Proposal for Supplement 2 to the 06 series of amendments to UN Regulation No. 10 (Electromagnetic compatibility)

Submitted by the Working Party on Lighting and Light-Signalling*,**

"Figure 1

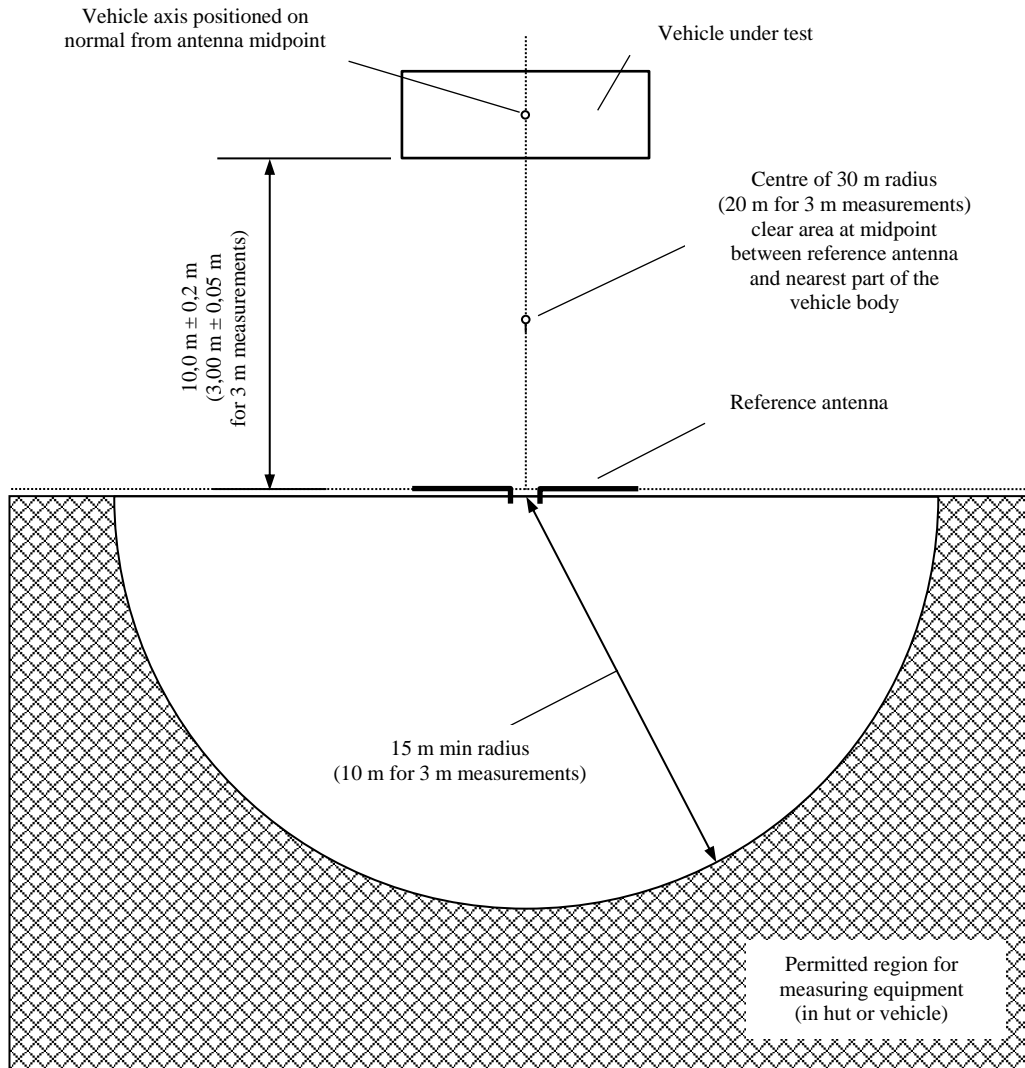
Annex 4 - Appendix 1,

Figure 1, amend to read:

Clear horizontal surface free of electromagnetic reflection delimitation of the surface defined by an ellipse
